PROJECT **123A90 - HOLLANDSE KUST NOORD WIND PARK**
BLPH Project

MECHANICAL COMPLETION DOSSIER (ONSHORE)

87-10-02

Junction Box 00-JE-11002 and Multi-core cable (PCS System)

C30002546

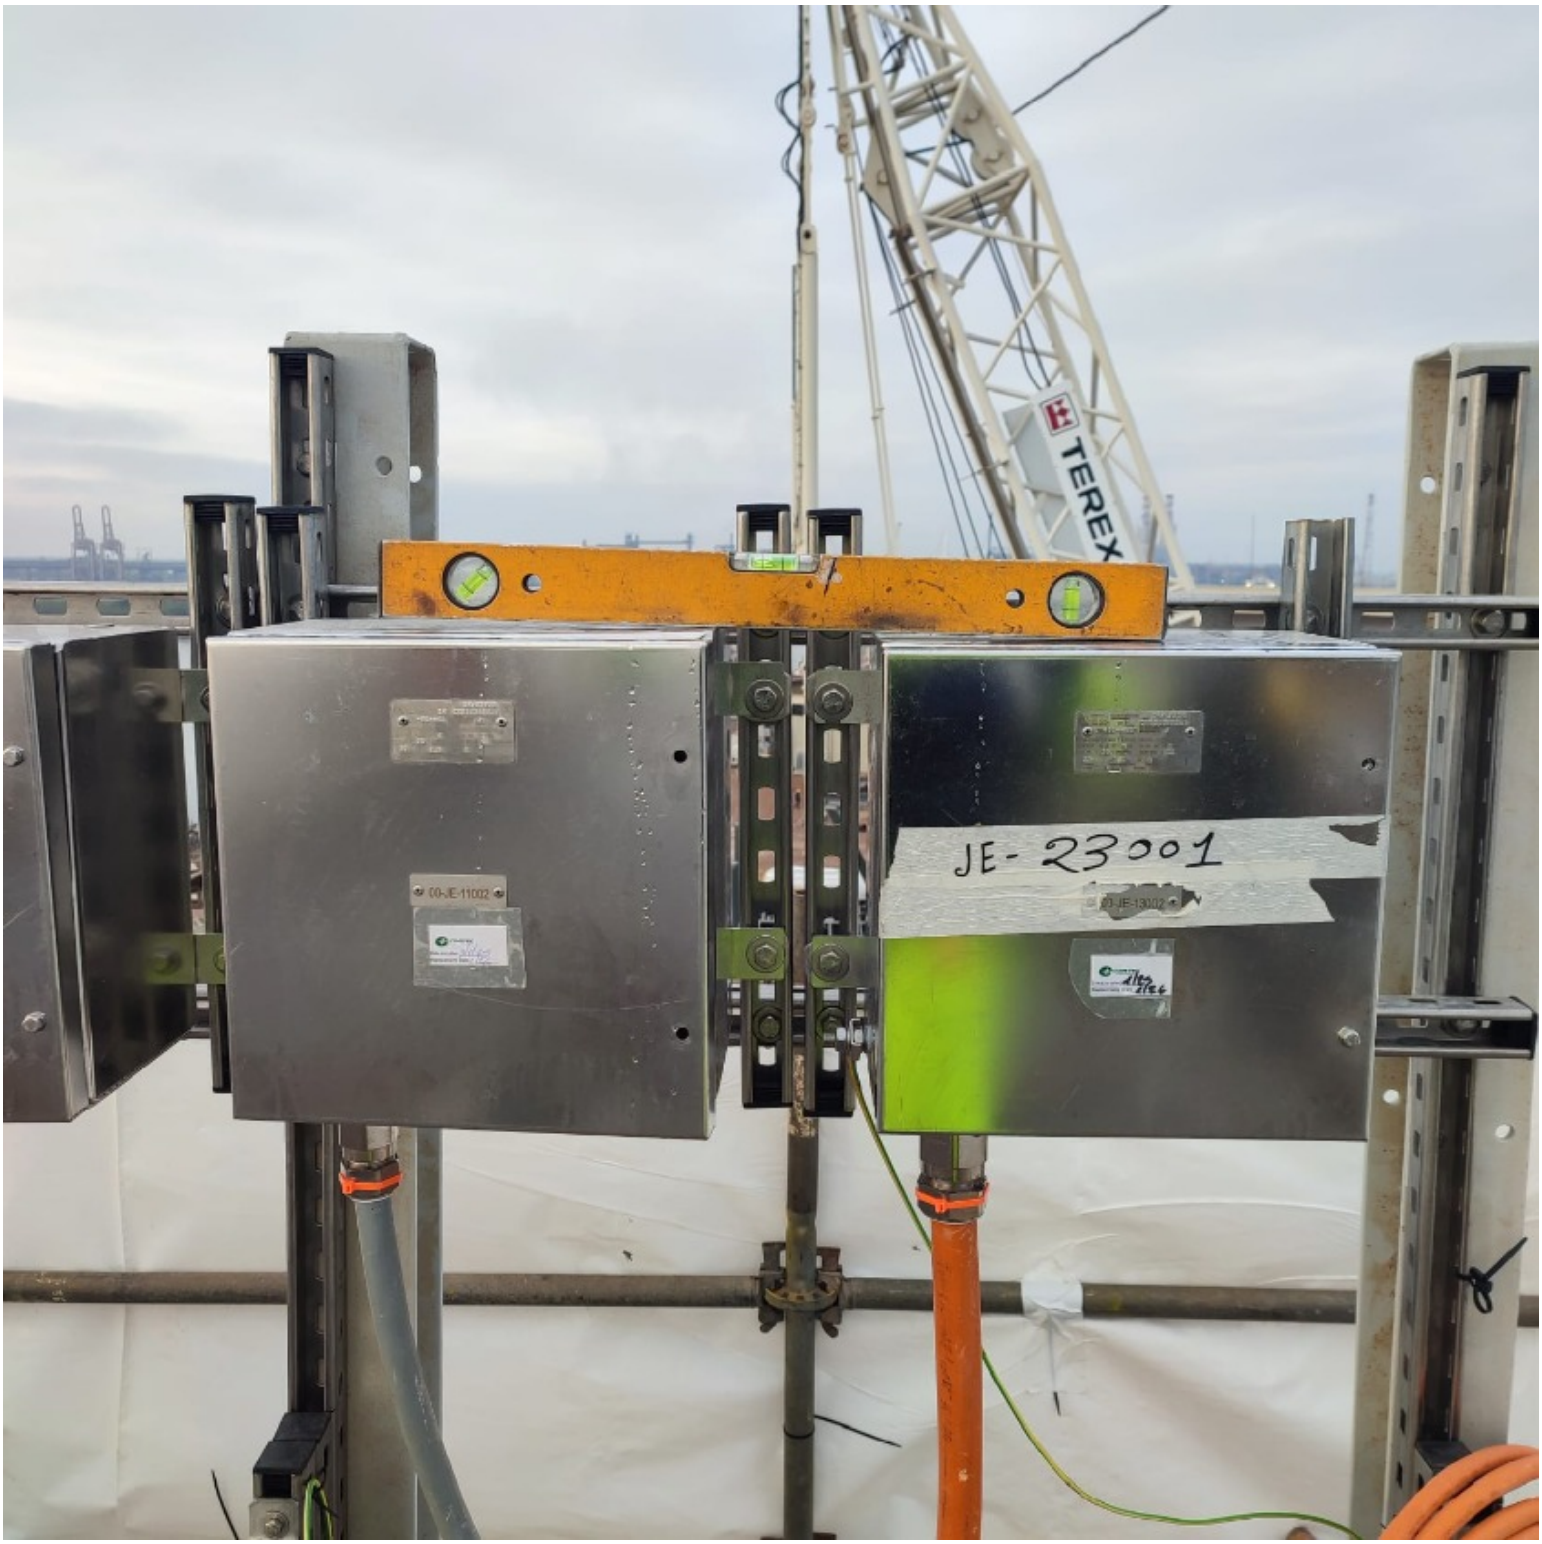
The JB is not aligned properly (00-JE-11002). See attached photo.

Done.
